Key Features of Proposed Master Plan

Summary of Jury Comments

Cox Richardson

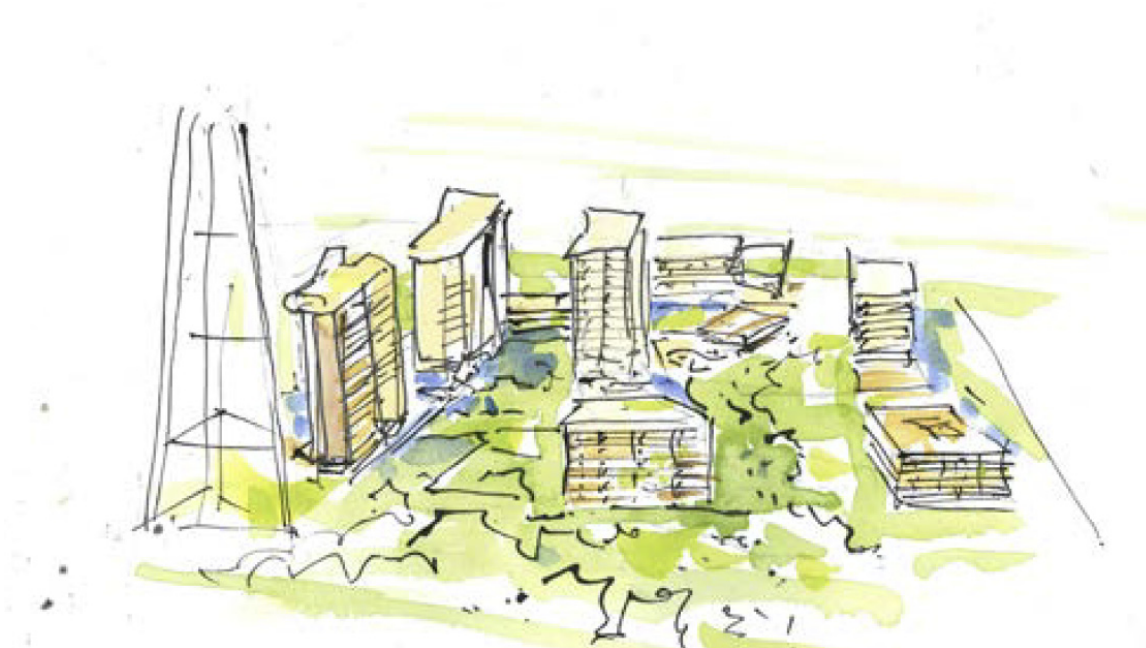
- The indicative architecture of individual buildings within the proposed master plan was highly refined and indicated an interesting and high quality aesthetic which could be achieved under the proposed master plan.
- The Jury raised concern that the primary area of green open space within the south-eastern corner of the Site would not be easily perceived as public open space and would therefore be of less utility to the broader existing community.
- The shared zone was viewed as a good vehicle circulation solution, but risked creating a public entrance to the site that is too urban and car-oriented.
- There was a concern that the positioning of a 12 storey building directly on the southern edge of the site would result in increased visual impacts.

Francis-Jones Morehen Thorp (FJMT)

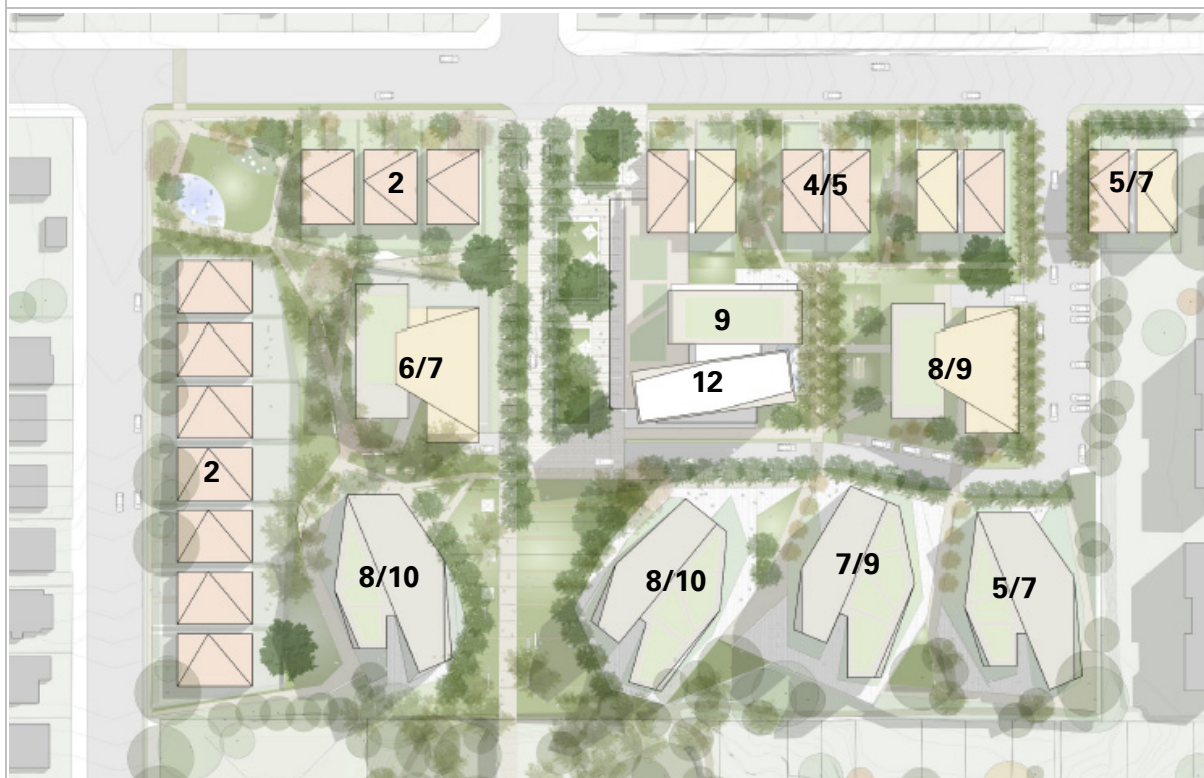
- FJMT's architectural response to the site was considered to be of a high calibre, with the 'boulder' apartment building forms considered to be an interesting and responsive approach to the site. Low-scale edge to Richmond Avenue with detached dwellings provides a potential improvement to the contiguous street edge of terraces in the approved Concept Plan.

- The high number of buildings within the scheme (21), particularly around the edges, resulted in a higher building footprint and less space returned to the broader community. In particular, the plaza space adjoining the roadway and some of the narrower spaces between buildings were quite urban and did not provide enough flexibility for future use by the wider community in their future use.

- The four taller buildings located immediately along the southern boundary of the Site with maximum heights of 7 and 10 storeys were considered to position too much building mass too close to the southern Site edge, result in greater visual impacts, additional overshadowing and transitional scale issues than the winning scheme.

BVN

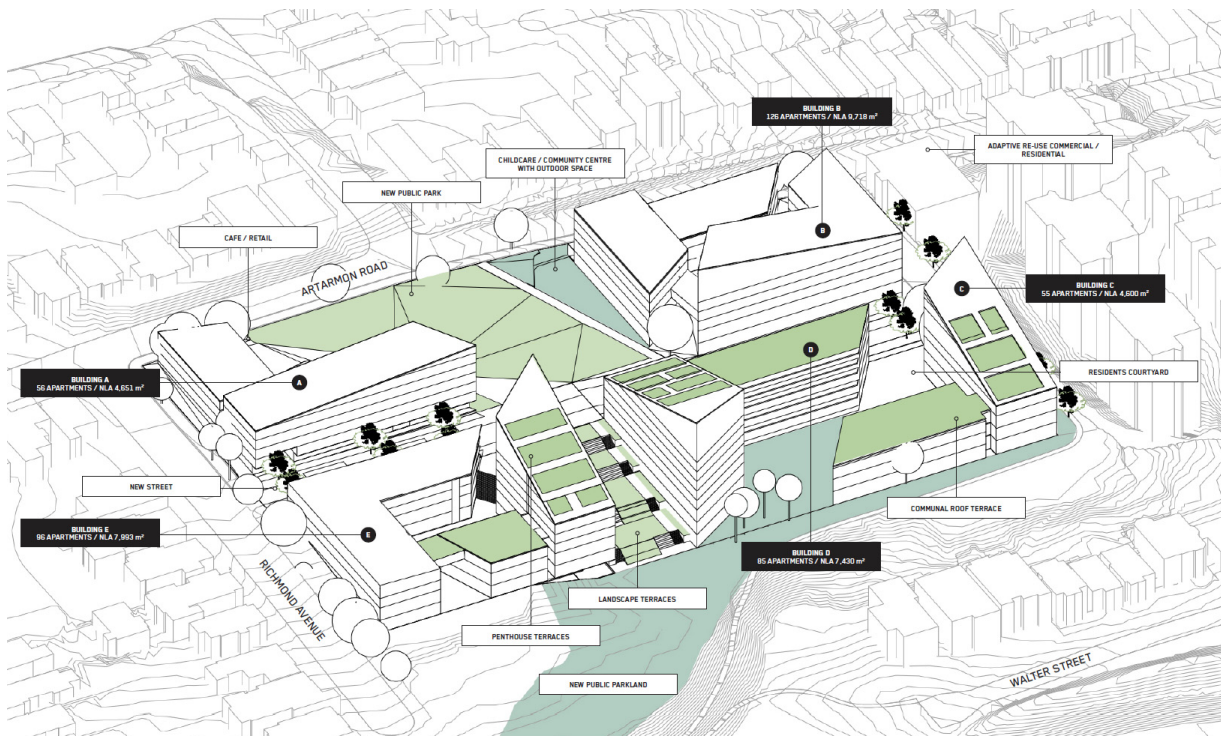
- The angular concept of the scheme was considered to be an innovative approach to the Site, however, there were concerns that the overarching concept did not respond sufficiently to the established character of the Site and locality, or to market expectations for a new residential community within the locality.

- Concerns were raised regarding the future amenity of internal courtyard-facing apartments in terms of solar access, visual privacy, acoustic privacy and outlook.

- The positioning of larger building elements close to the southern boundary of the Site, with buildings up to 10 storeys + roof feature, was considered to have greater visual impact, overshadowing and transitional impacts than the winning scheme.

- Whilst the public open space at the Edward Street terminus was considered to offer a positive community outcome, the nature and public accessibility to other open space areas within the Site was considered to be less resolved and feel more like communal open space due to the high level of building enclosure.

SJB Architecture

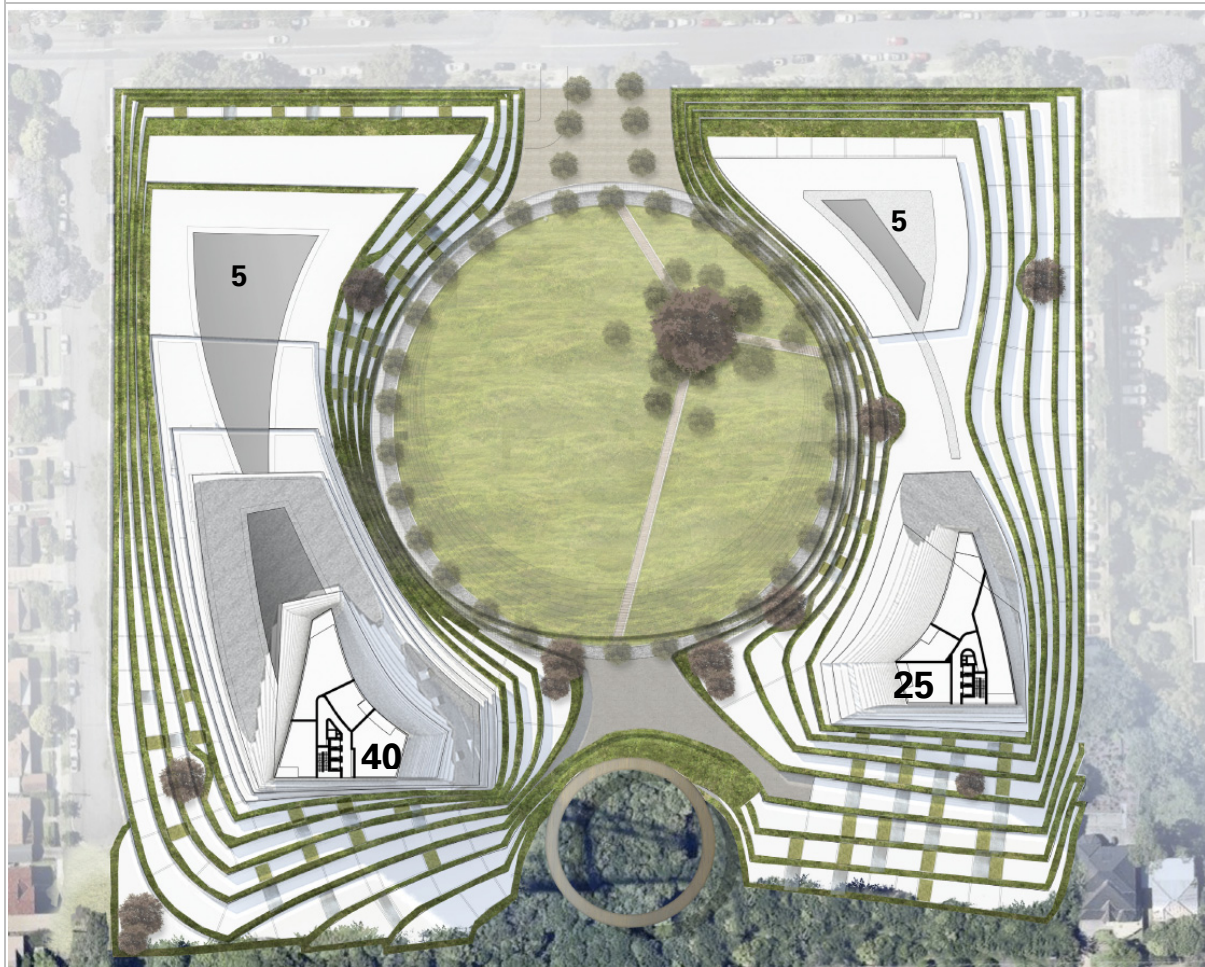
- The SJB made a positive contribution to the competitive process by providing an interesting conceptual approach to the constraints and opportunities of the Site
- The height and density of development proposed, including a 25 and 40 storey building, was not considered to be appropriate for the site given the extensive planning history. Similarly, the number of apartments proposed was well in excess of the current Concept Plan approval. For these reasons, it was considered that the scheme was not capable of obtaining a planning consent.
- The inclusion of the Walter Street Reserve within the development site area, whilst interesting, was not considered to be practical from a development perspective.
